Proposal for draft amendments to Regulation No. 118 (Burning behaviour of Materials)

A. PROPOSAL

Example 2

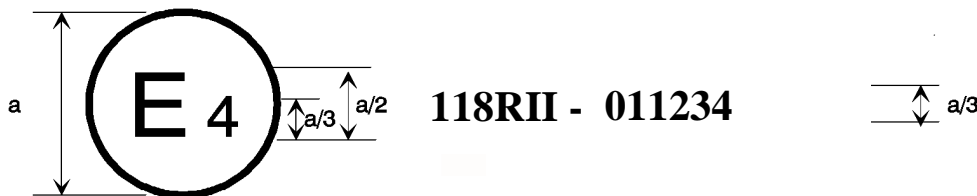
The above approval mark affixed to a component shows that the type concerned was approved in the Netherlands (E4) pursuant to Part II of Regulation No. 118 under approval number **011234**. The first two digits (**01**) of the approval number indicate that the approval was granted in accordance with the requirements of the **01 series of amendments to Regulation No. 118**.

Figure 4
Apparatus for testing the capability to repel fuel or lubricant
(Dimensions in millimeters)"

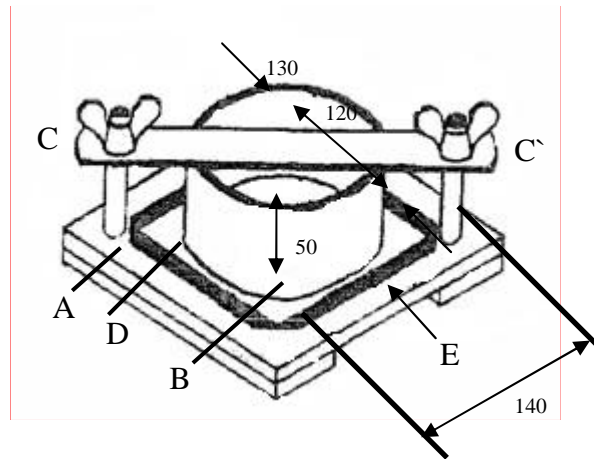
- A ~~a base plate with an absorbant surface~~ **on the baseplate** (e.g. paper);
- B a metal cylinder (inner diameter of 120 mm, outer diameter of 130 mm, height of 50 mm), filled with the test liquid;
- C - C` two screws with wing nuts;
- D the test sample;
- E a seal **base** plate, with a hardness of **at least** 70 Shore D.
